ARCHITECTURAL REVIEW BOARD MEETING- SPECIAL MEETING

Meeting Date:	July 7, 2026
Agenda Title:	COA 26-16 22 Waterloo Street
Requested Action:	Proposed Rear Addition, Door Replacements, and Façade Improvements
Department / Agency Lead:	Community Development
Staff Lead:	Whitney Burgess, Preservation Planner

ARCHITECTURAL REVIEW BOARD
CERTIFICATE OF APPROPRIATENESS 26-16

Meeting Date:	July 7, 2026
Agenda Title:	COA 26-17
Requested Action:	Construct new board-and-batten cap fencing along the northwest property line
Department / Agency Lead:	Community Development
Staff Lead:	Whitney Burgess, Preservation Planner

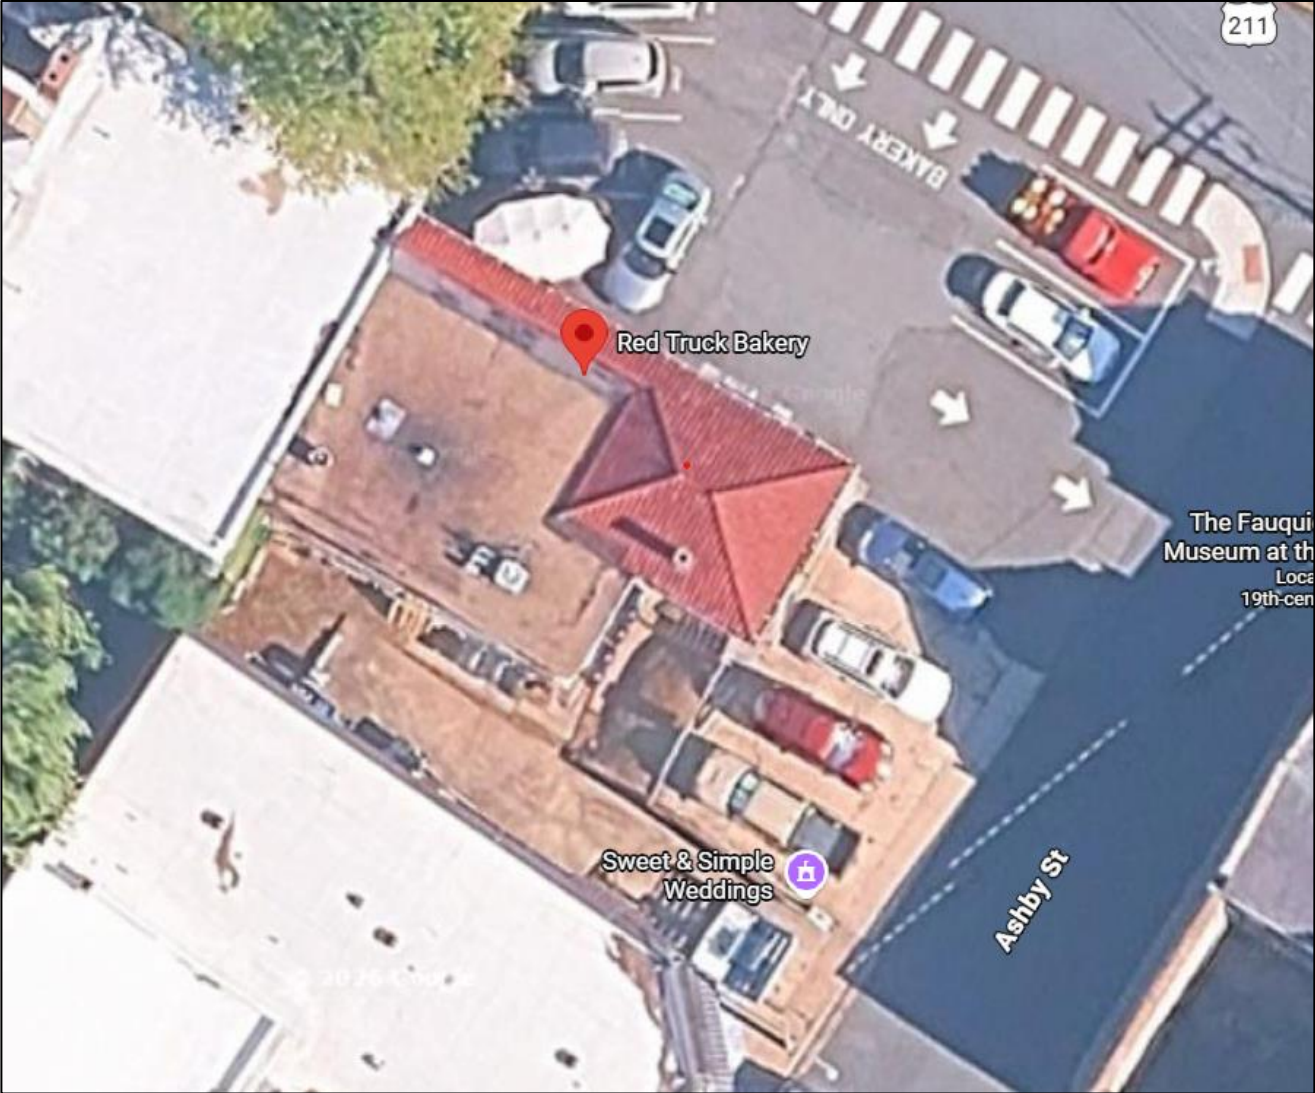
Prior Feedback from Work Session 5/28/2026:

- Incorporate parapet construction at the roofline to provide a buffer to conceal any roof-mounted HVAC, set back 4-5 ft while maintaining the roofline. Avoid replicating the appearance of the historic tile roofing.
- Maintain the current fenestration pattern and in-set (plane) of the garage doors to the greatest extent possible when choosing replacement access doors. Although the extant garage doors are wood, metal or steel doors would be an acceptable option.
- Return to the use of stucco on the exterior of the new addition, but with a different variant or texture than what is on the existing building.
- Include a detailed plan of the "cellar" area within the new addition.

Staff has confirmed that ARB feedback from the Work Session was incorporated into the most recent plans (see Attachments 1 and 2).

Rendered Perspective
Rear Improvements for the Alley and Asby

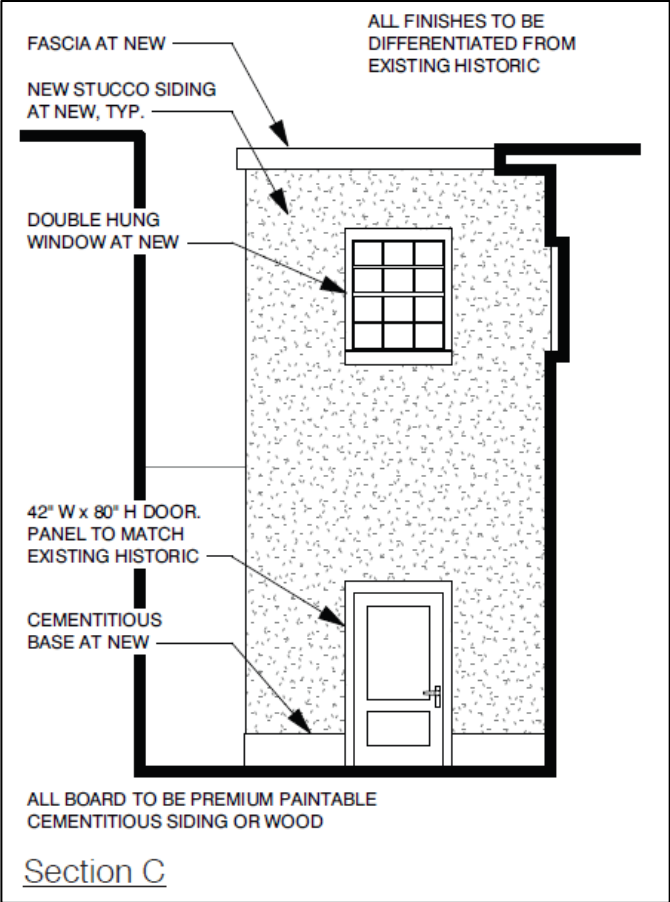
Mr. Burch asked if it would be possible to replicate the doors and windows as to what it looks like right now, not slightly different as the AI rendering shows. The doors would not still need to be non-fixed.

Mr. Scoggin stated that the current proposal seems to detract from the historic value of the building and to maintain the current scale of the doors.

Mr. Hemmingson stated that the proposed layout seems agreeable but agreed that the current scale of the garage doors should be maintained, as seemingly shown in the draft drawings.

NOTE: ANY CHANGES TO ROOF TOP MECHANICAL EQUIPMENT WILL BE SET BACK 48" MIN. FROM EDGE

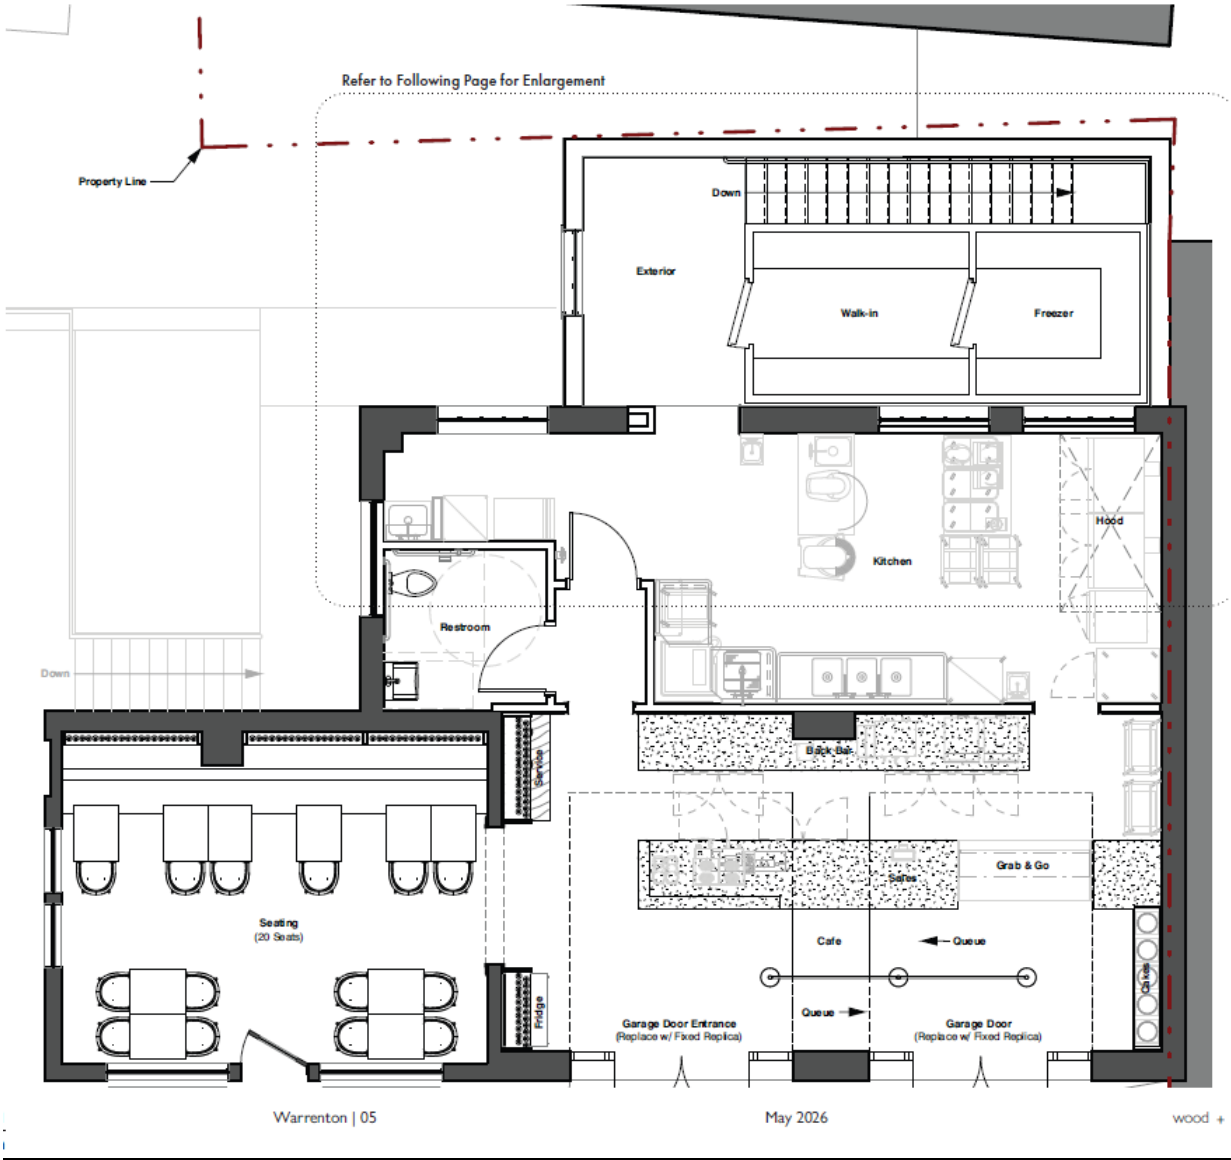
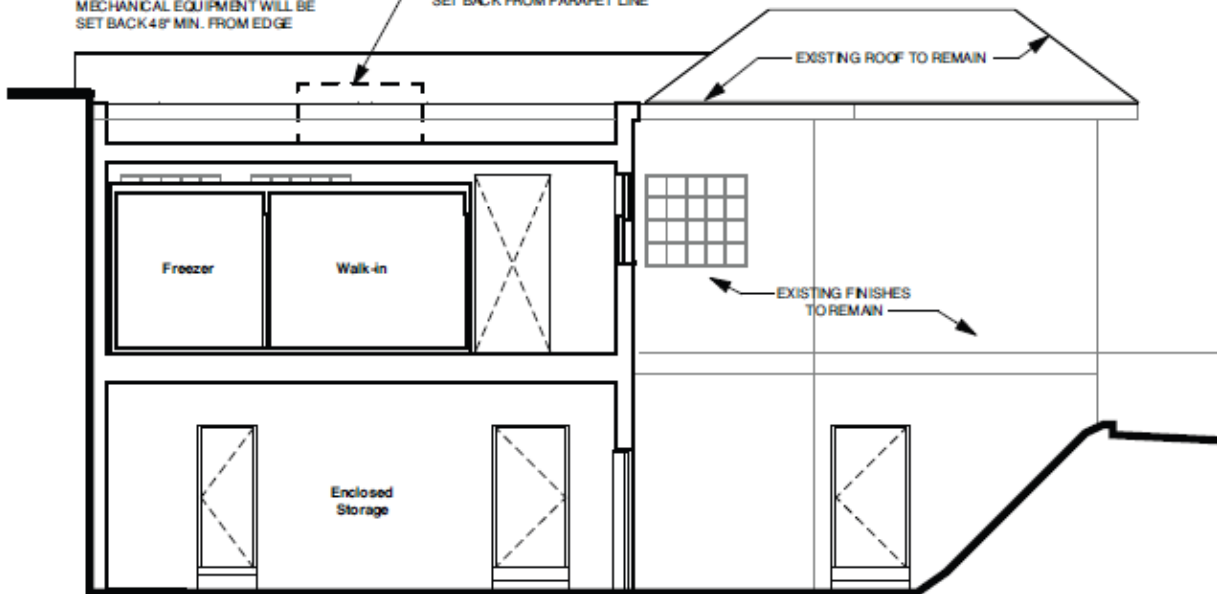
Mr. Beidler asked about any HVAC equipment and proposed a parapet wall on the rear/side elevations to conceal all utilities – would not support tile, but maybe a simple stucco parapet wall.

Ms. Burgess agreed that a more utilitarian approach to building a parapet would be more appropriate and to avoid mimicking the historic tile roof.

The contractor asked if an inset parapet would be appropriate, as long as it's set back 4-5' and maintains the current roofline design.

WALK-IN MECHANICAL EQUIPMENT SET BACK FROM PARAPET LINE

Basement Level Plan (At Rear Grade)

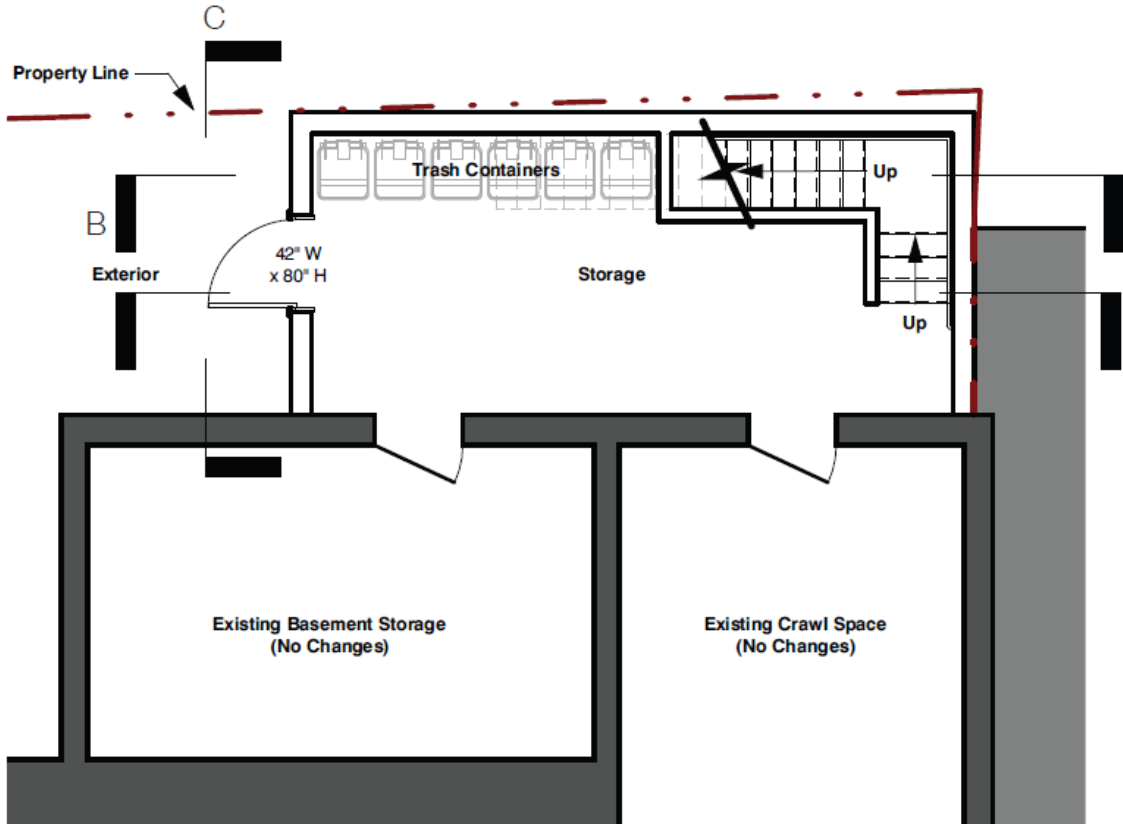
Mr. Hemmingson asked for a cellar plan.
